9.2 NO. 188 (LOT: 1; D/P: 33790) VINCENT STREET, NORTH PERTH - PROPOSED ALTERATIONS AND ADDITIONS TO PLACE OF WORSHIP (AMENDMENT TO APPROVED)

RECOMMENDATION:

The purpose of this report is to consider an application for development approval for Alterations and Additions to Place of Worship (Amendment to Approved) at No. 188 Vincent Street, North Perth (the subject site).

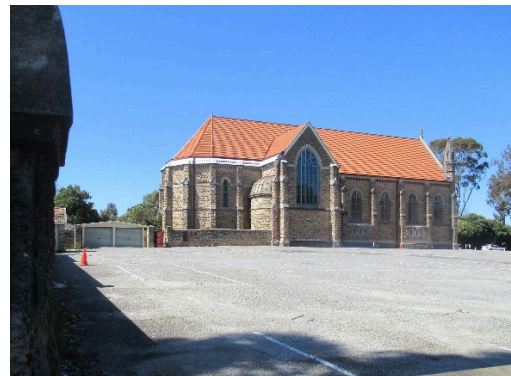
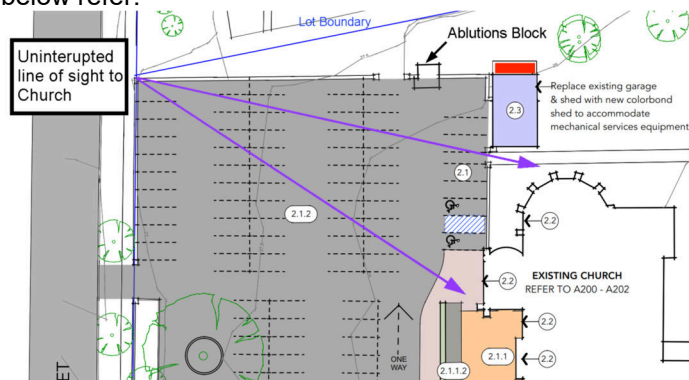
- **Maintenance of Views and Vistas:** The proposed outbuilding would not impact views of the Church and Monastery from Vincent Street. Existing views of the Church from Alfonso Street would be maintained. The Conservation plan identifies views from Vincent Street as being of Considerable Significance to the place. Alfonso Street provides views of the side and rear of the Church and is not the primary viewing point for the site identified in the Conservation Plan. The car park to the west of the Church is bounded on the north and east by a limestone fence that is approximately 1.9 metre high and was constructed in 1956. A masonry and tile ablutions block is located approximately 39 metres from Alfonso Street and is integrated into the northern portion of the limestone wall. This means that views of the Church from Alfonso Street are interrupted and would not be further impeded by the proposal. The figure and image below refer.

The proposed outbuilding would not interrupt existing views of the Church from the northwest corner of the car park due to its separation from the Church building. Photographs of the existing views from the northwest corner of the car park are available in **Attachment 4**; and

This Sheet
Plan Elevations - Plantroom Proposed

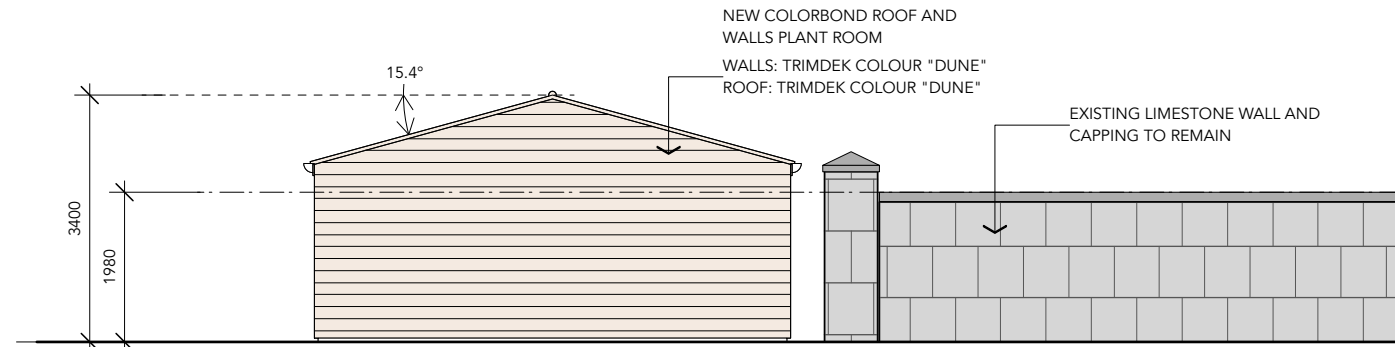
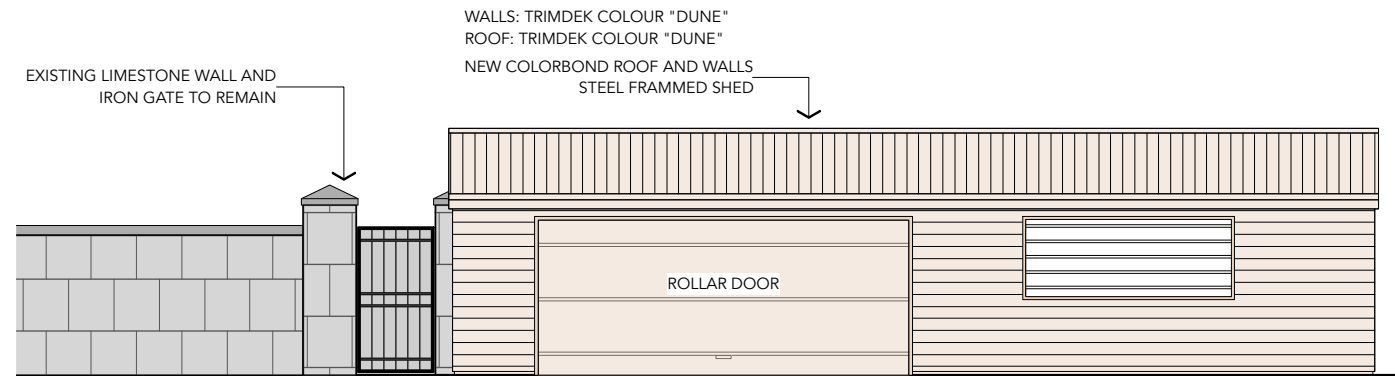
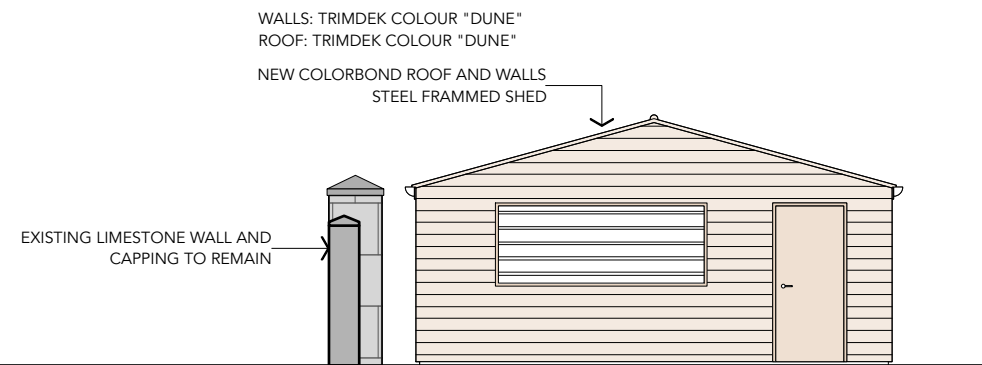
- The location and design of the proposed outbuilding would be subservient to the Church to the south east. The proposed outbuilding has been designed to be similar to the existing outbuildings on-site in terms of size and location. The larger of the existing outbuildings is clad in sheet metal and was approved to be reclad as part of the previous approval. The utilitarian design and use of sheet metal is consistent with other outbuildings on the site and was noted by the DRP member as an appropriate material for a utility structure;

- **Sympathetic to Existing Heritage Values:** The proposed outbuilding would be in the same location as existing outbuildings. Outbuildings are an established part of the built form of the site. The proposed materials and finishes are consistent with existing outbuildings within the wider Monastery and Church complex which have typically been utilitarian in nature. These include the corrugated metal outbuildings to the north of the Formal Garden. The proposed outbuilding would be finished in a neutral 'Dune' colour, 'trimdek' sheet profile and steel-framed construction and would be modest in scale in the context of the subject site and adjoining Church. It would measure 12.3 metres long by 6.3 metres wide, with a wall and ridge height of 2.2 metres and 3.4 metres respectively. This would ensure that it would be subservient to the adjacent Church, which has a wall height of approximately 9.7 metres;

- Site Presentation to Alfonso Street: The existing southernmost outbuilding presents two garage doors in a sheet metal wall to the Alfonso Street elevation. The proposed outbuilding would provide a sheet metal wall, with a roller door to the Alfonso Street elevation. Across the entire Alfonso Street elevation of the subject site, the Church and Monastery buildings would provide visual interest to Alfonso Street. This includes the Narthex that was approved by Council in December 2022. In addition to the existing limestone Church, the Narthex would sit 6.4 metres forward of the proposed outbuilding and includes large format glazing and copper roofing to complement the existing Church; and

Images Included with Submissions

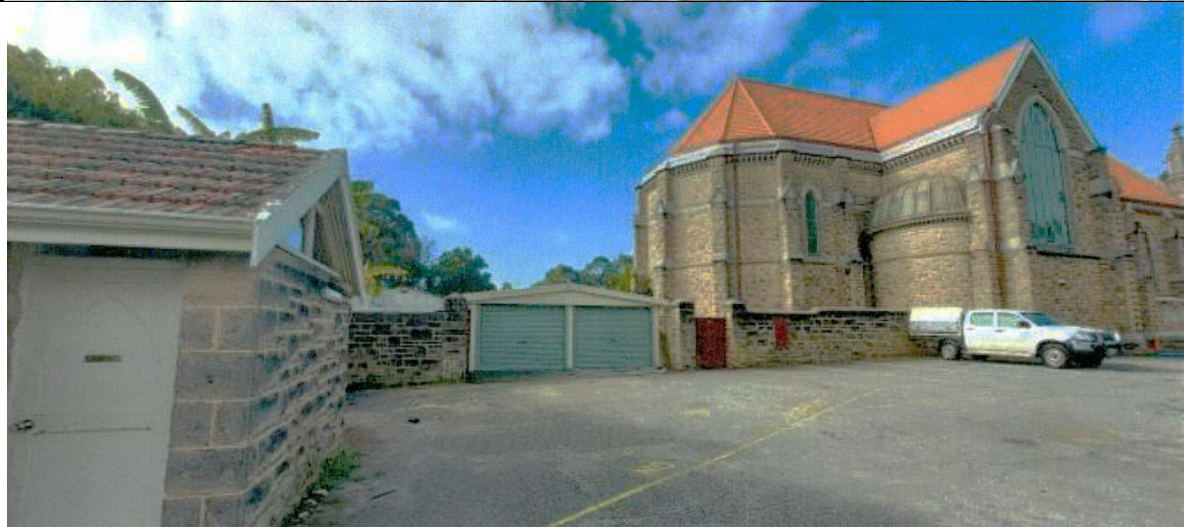
Enhance vista from Alfonso Street by removing the Colorbond gabled shed and exposed roller doors.

Relocating the plant room behind the existing garden wall will allow breathing space and appropriate distancing to the Church ambulatory.

Relocated and realigned plant room to provide great separation to the Ambulatory and enhance vistas.
